January 2013 Environmental Update for SLEMA Board

Zhong Liu
January 31, 2013

Predicted Ammonia Concentrations in Snap Lake

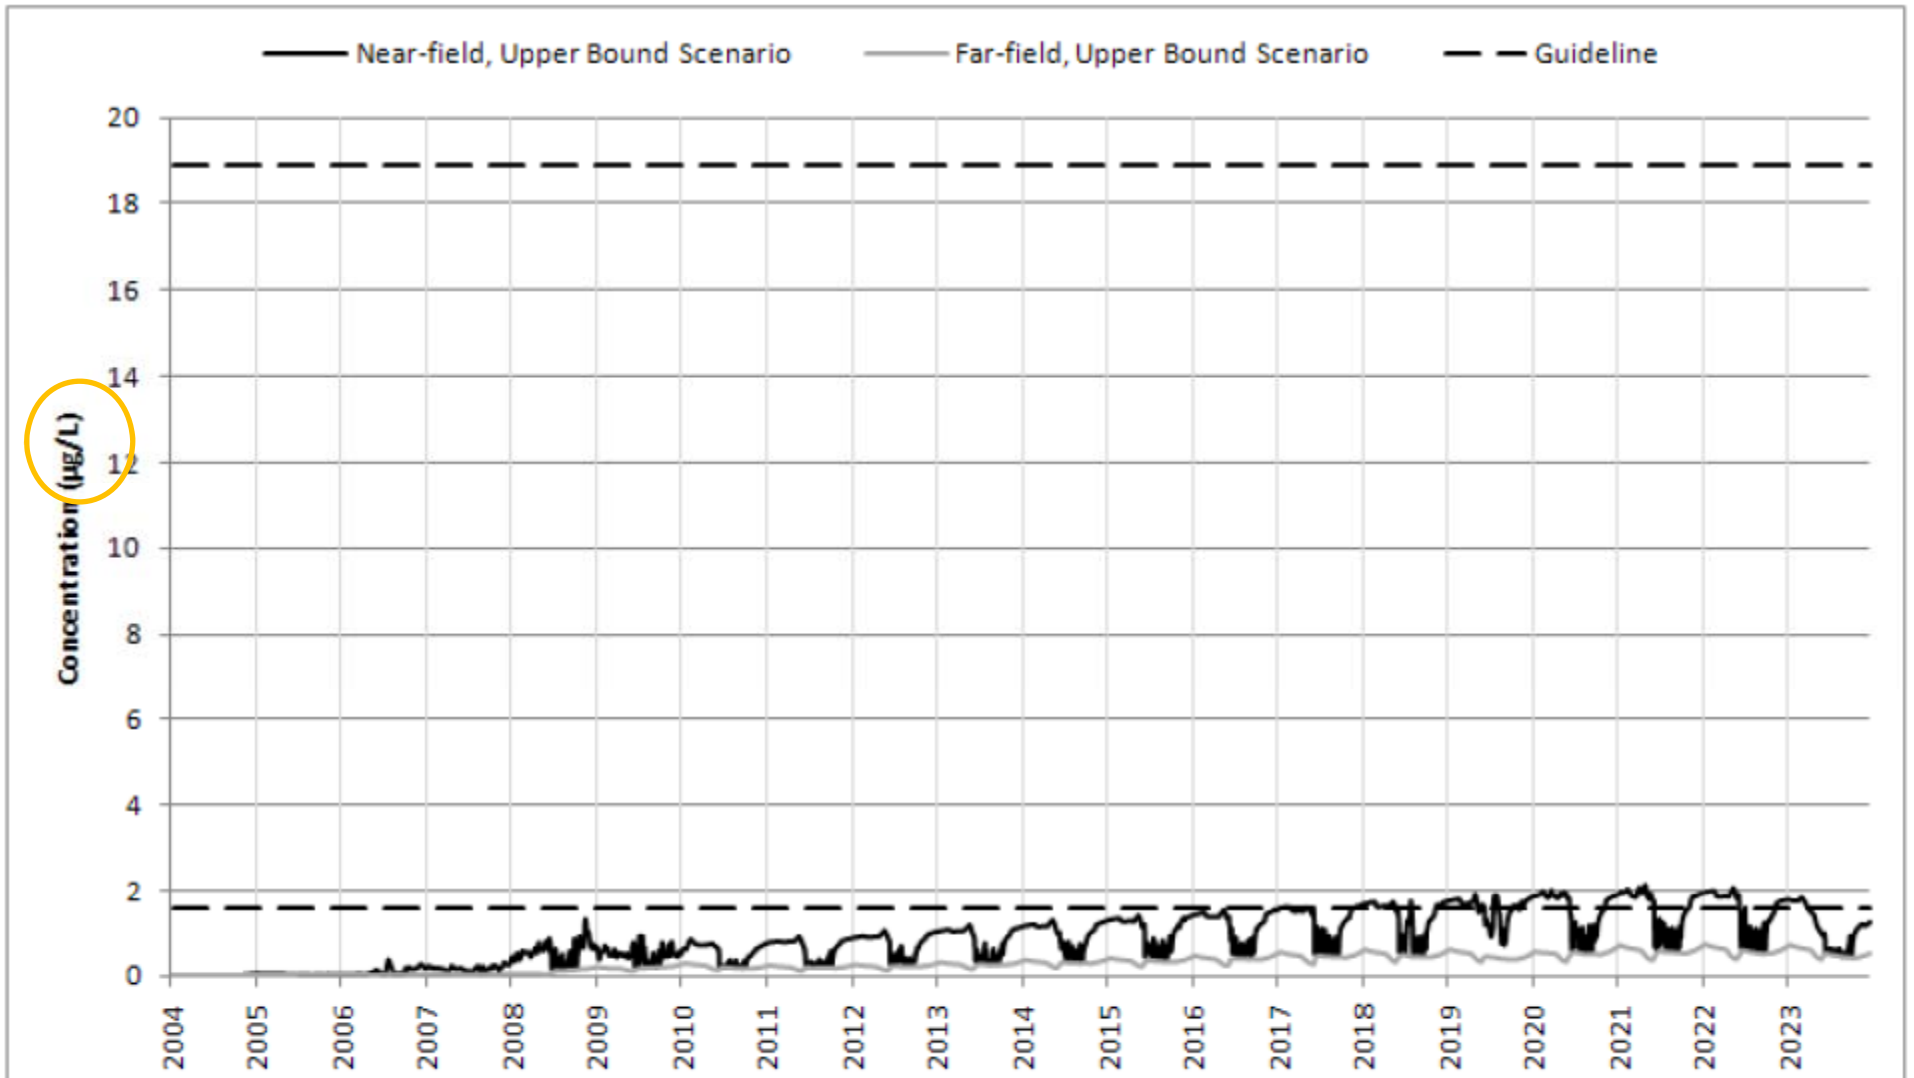
- The unit used in Figure IV.15 and 16 of Lake Model Report should be mg/L, rather than $\mu\text{g/L}$
- Looking forward to reviewing the technical memorandum about modeling update to be submitted by De Beers in February 2013
